# Part IV of January 18, 2017 PZC Agenda Packet

TO: Planning & Zoning Commission  
FROM: Heather Valone, Village Planner  
THRU: Jeffery Stein, Deputy Village Administrator  
SUBJECT: Case 14-12 Donegal Excavating PUD  
DATE: January 4, 2017

Case No. 14-12  
Project Name Donegal Excavating

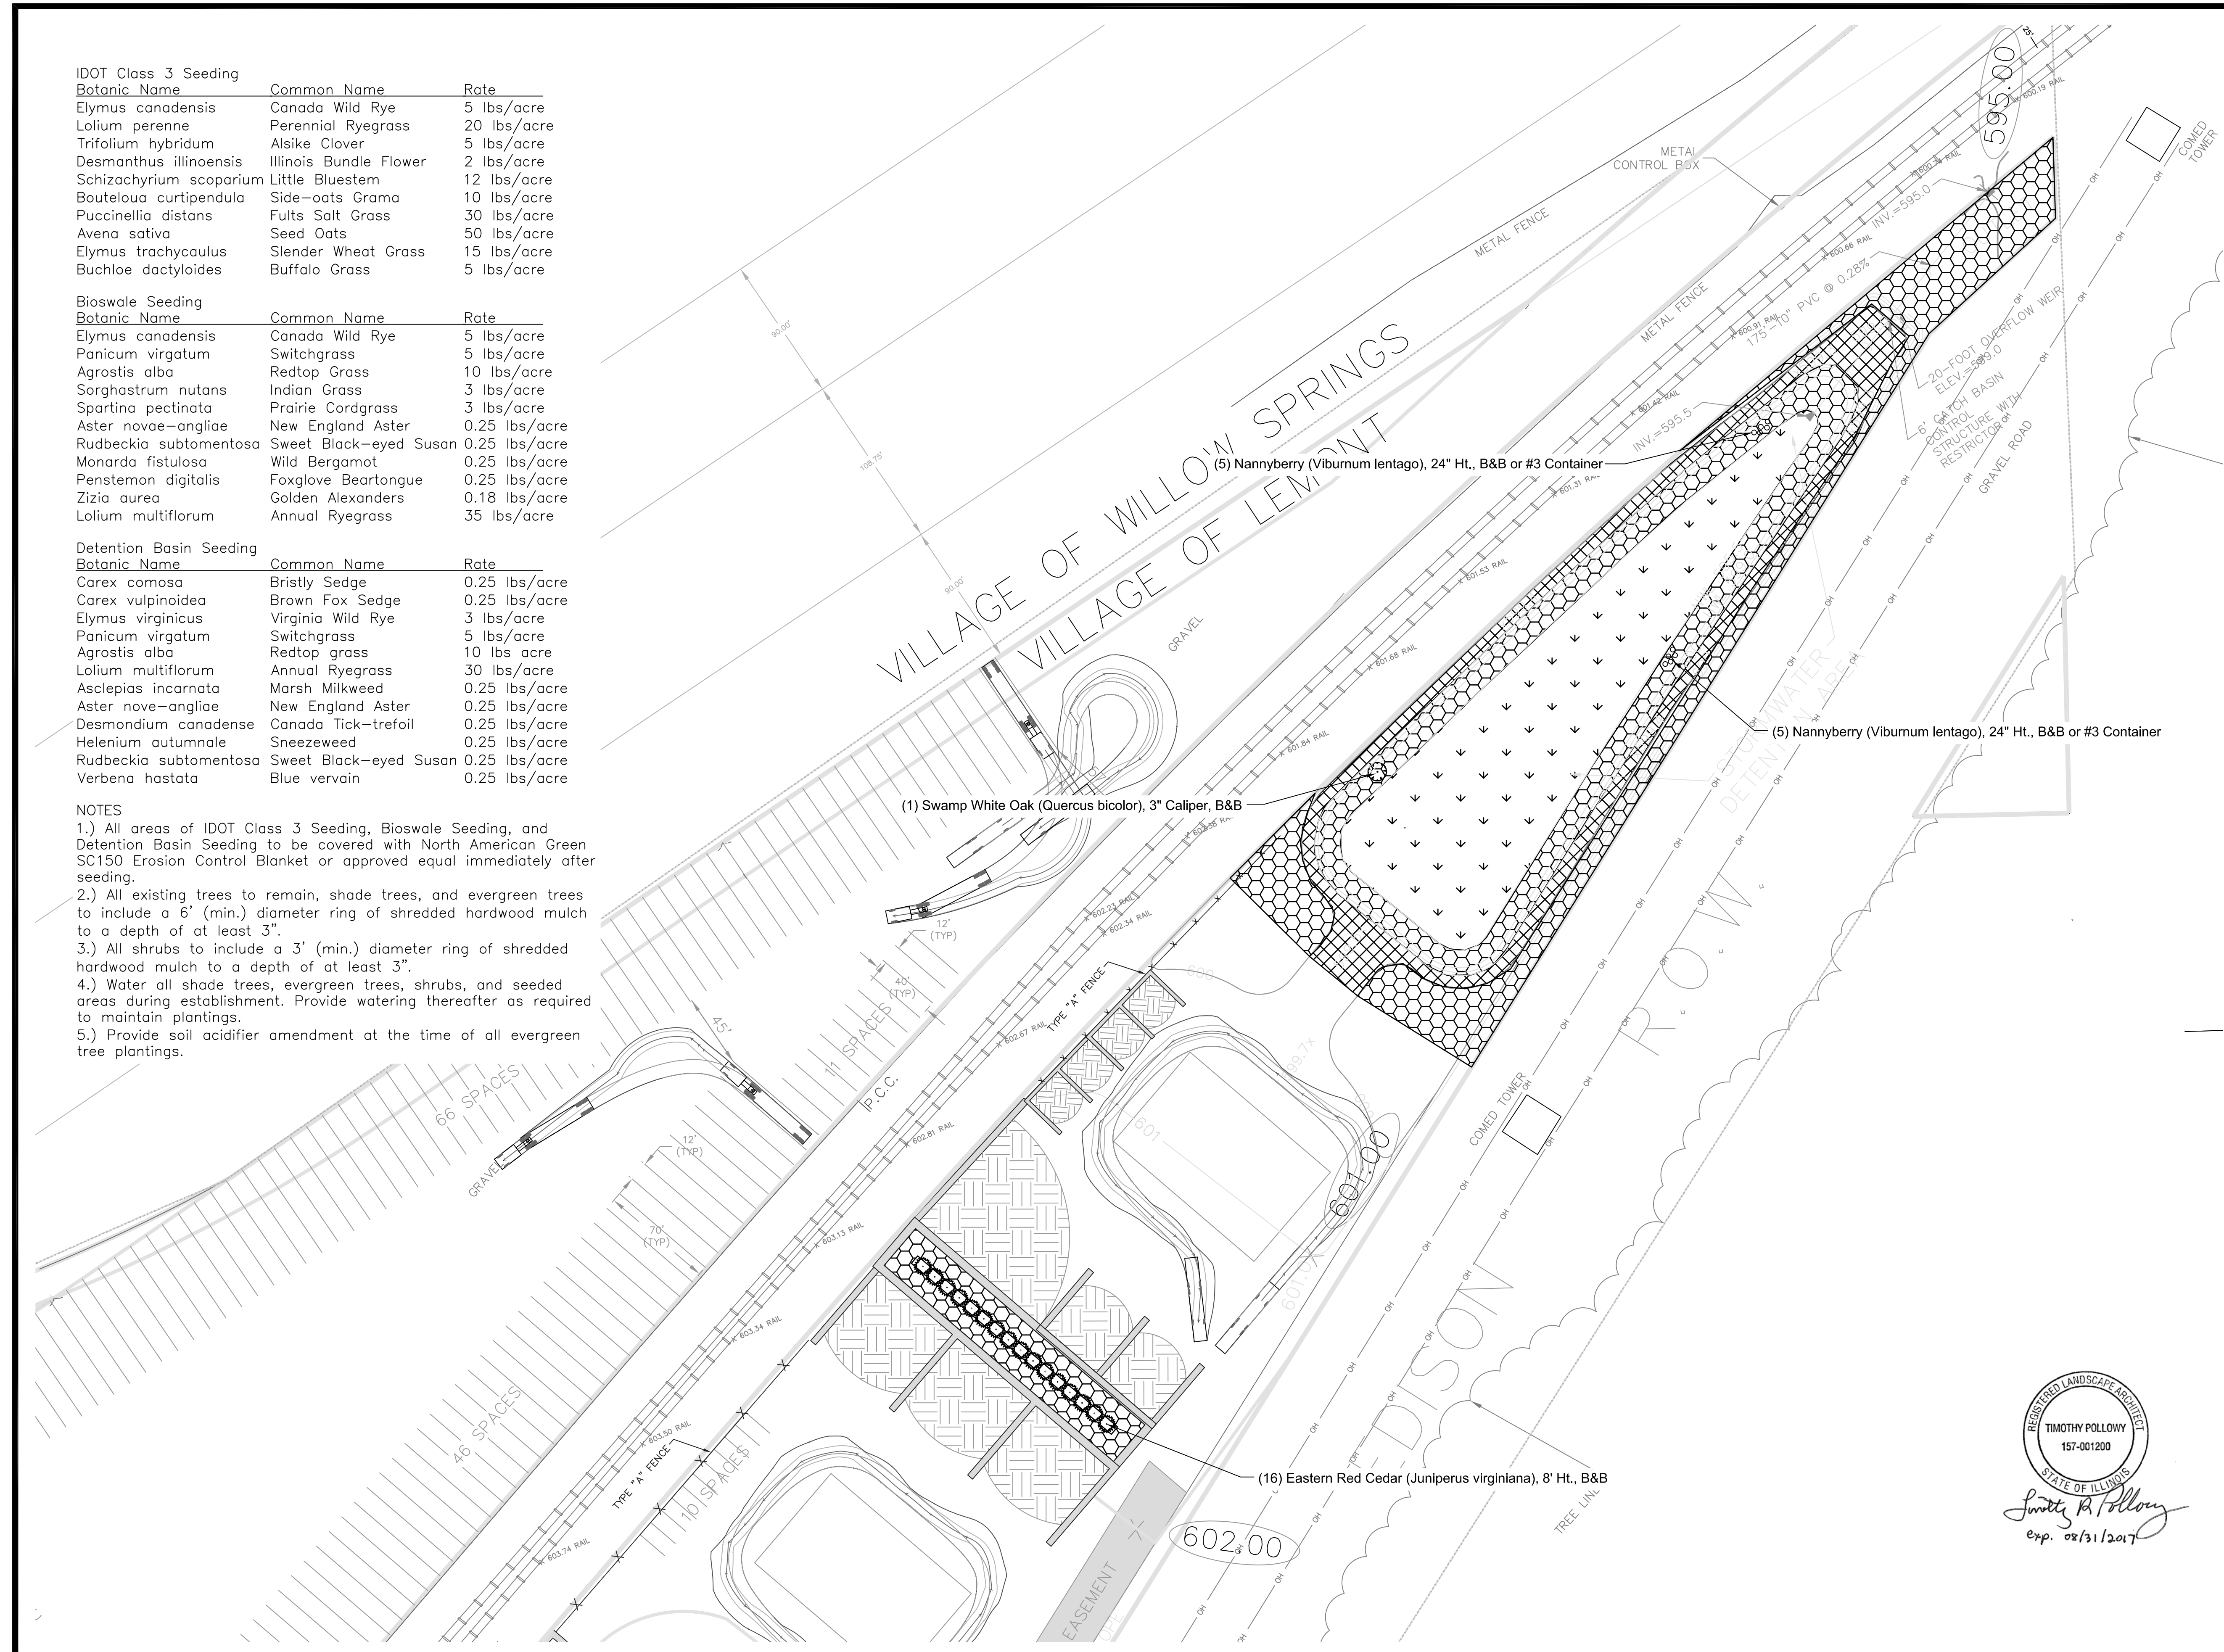
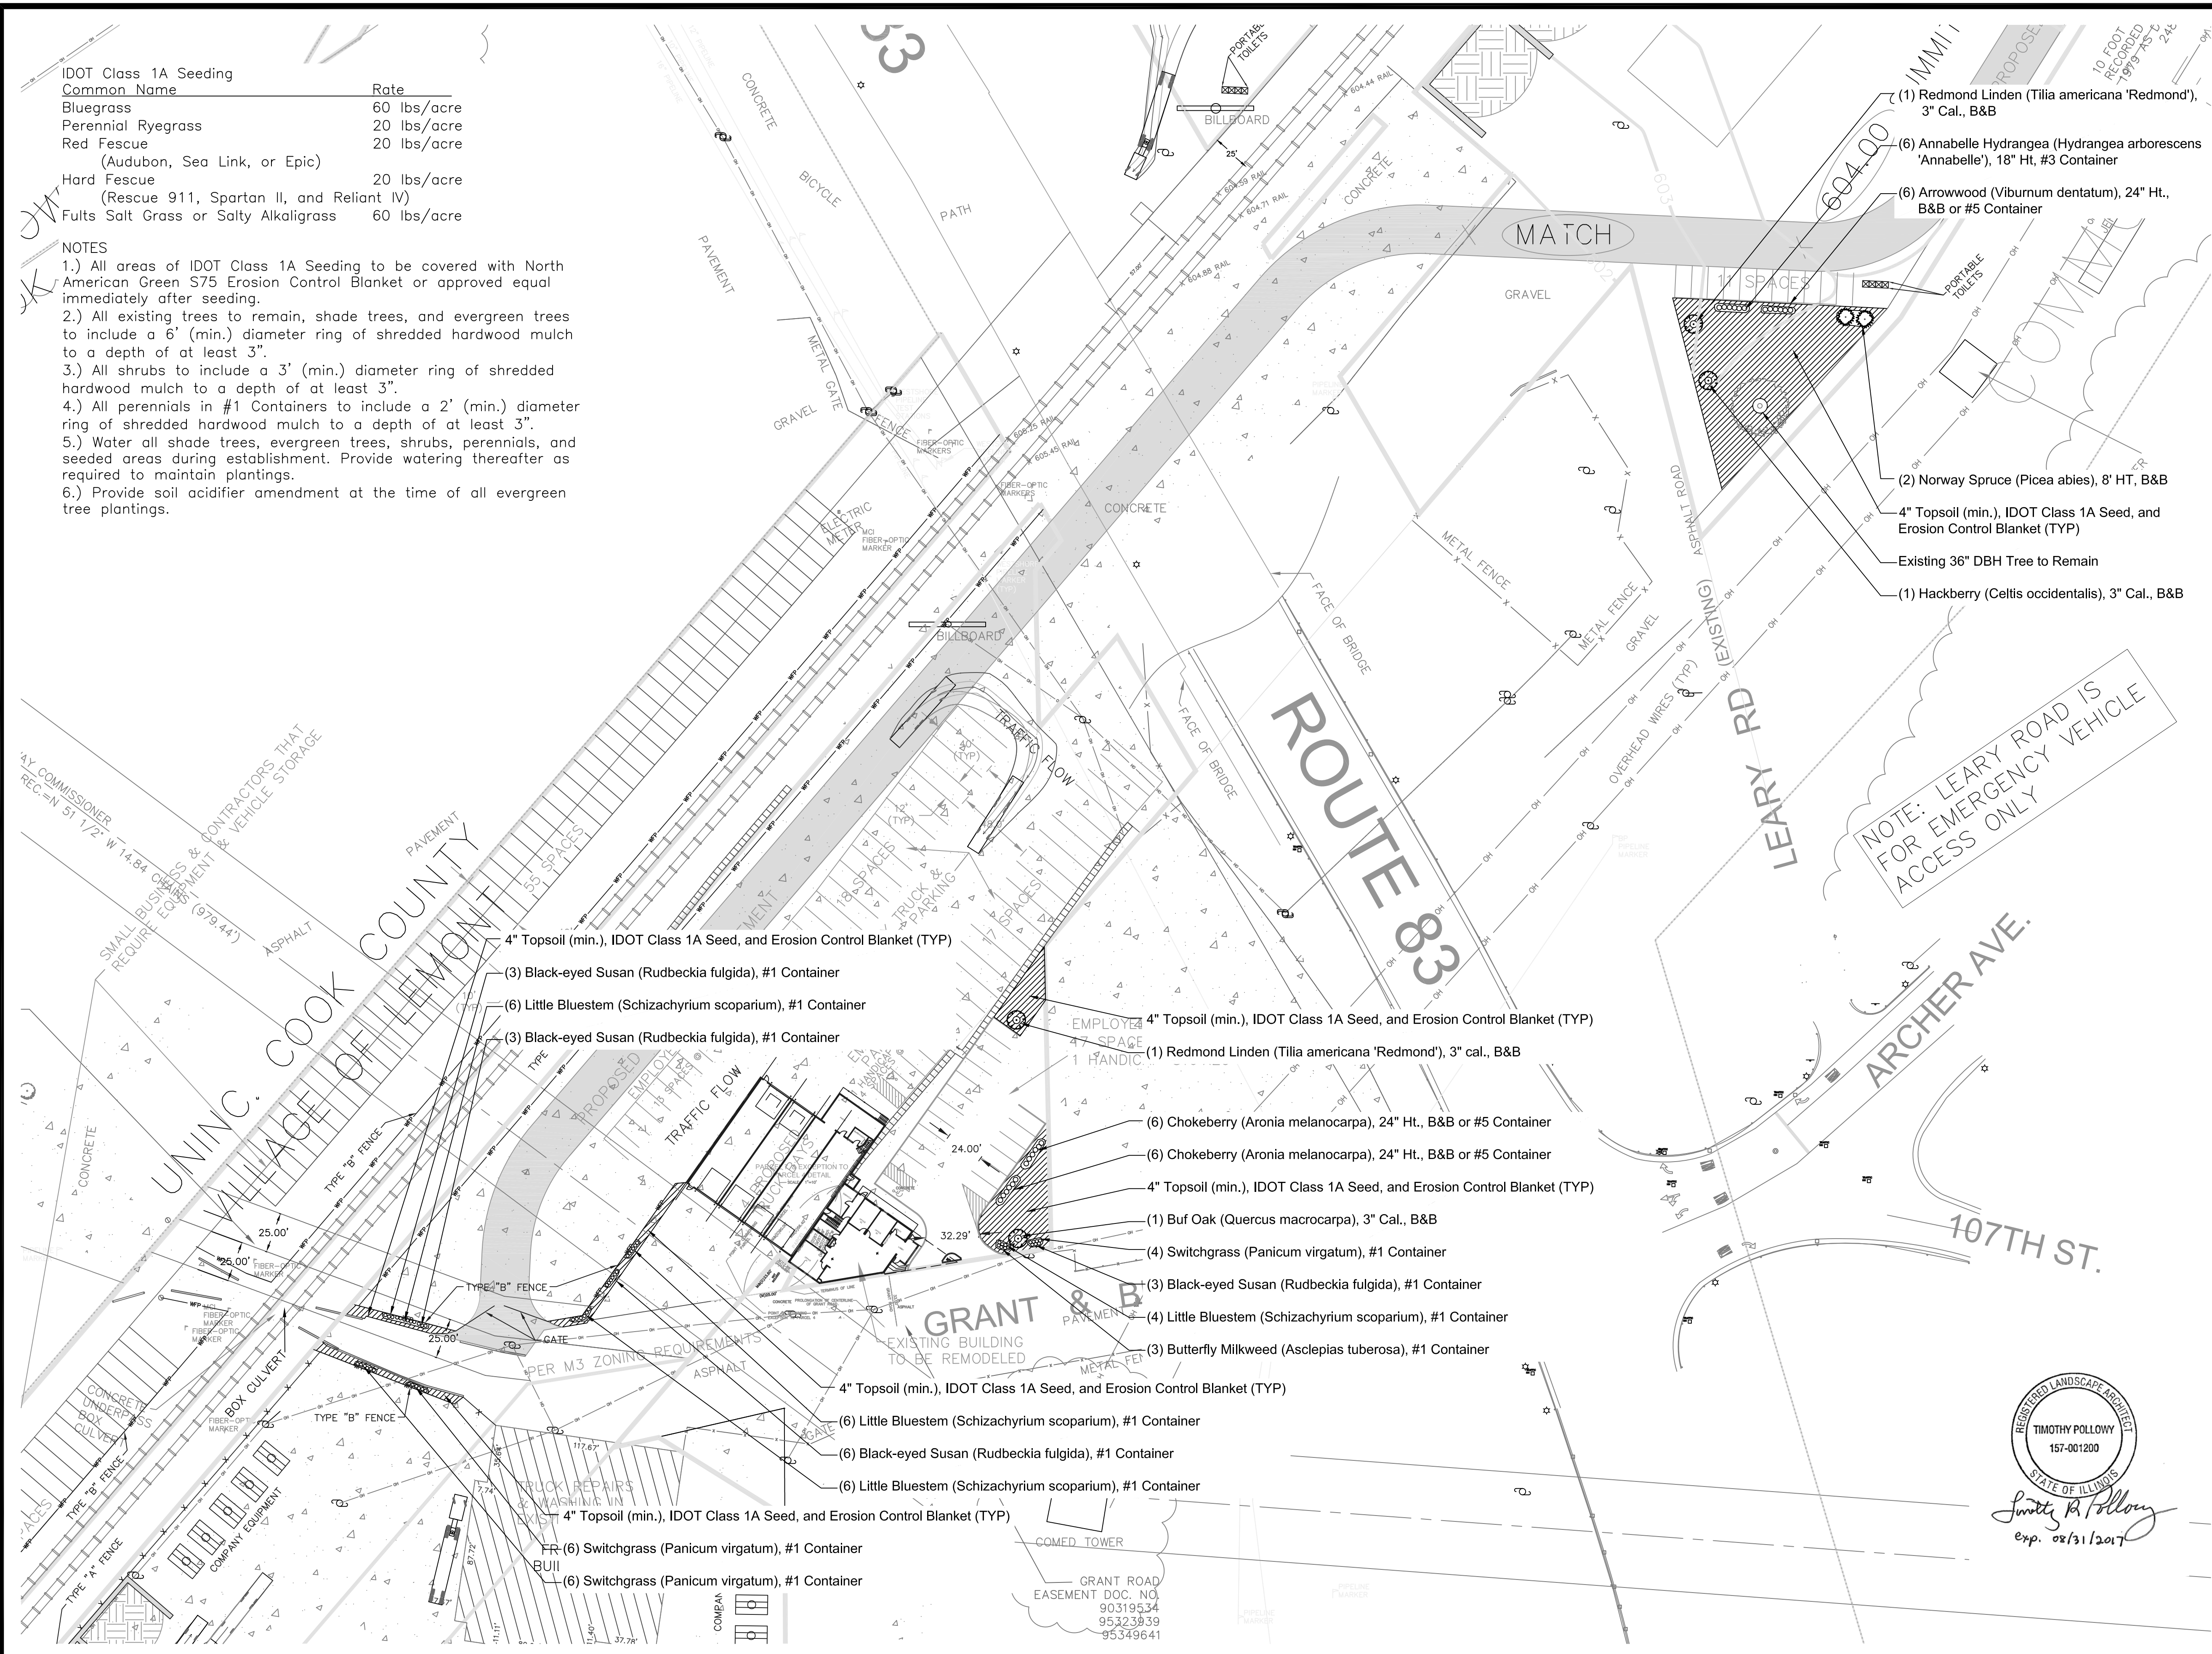
The landscaping plan and the engineering plans depict different amounts of landscaping along the private road through the box culvert. These plans must be revised to be consistent with one another and not contradictory to each other.

The Village Arborist reviewed the application and noted that the proposed plants are suitable for the industrial sight. There are deficiencies in the employees' parking lot landscaping which should be revised. The Village Arborist had no concerns with the use of fencing along the railroad tracks being used in lieu of landscaping along the parcels north of the tracks. Information on the existing trees is missing and requested by the Village Arborist to be included on the landscape plans.

1. The landscape plan notes indicate that all existing trees will be retained. There are three tree symbols on the existing conditions plan, but there was no information as to the species size and condition of the trees. The landscape plan shows one 36" D.B.H. tree to remain. The species and condition of the tree were not provided.

2. The landscaping opportunities for this site are limited. The landscape plan is generally suitable to the site. The proposed landscaping for the storm water detention area is not consistent with landscape standards in Section 17.20.080 of the Village Ordinance.

3. The use of fencing along the north side of the railroad ROW instead of landscaping for the truck and equipment parking is acceptable. The landscaping in the normal employee parking lots must be revised to increase the landscaping and landscaped islands.

3. Revise the landscaping plan to include at least one (1) plant unit per 100 ft. of frontage along Grant Rd. and Leary Rd.
4. The landscape plans must also be updated to increase the landscaping around the exterior of the employee parking area.

5. Incorporate 595 sf. of landscaped islands between the employee parking area and the truck/equipment parking area on Lot 2.
6. Update the engineering plans and the landscape plans to show the same landscaping and fencing information and show a fence along the railroad ROW on Lot 6.
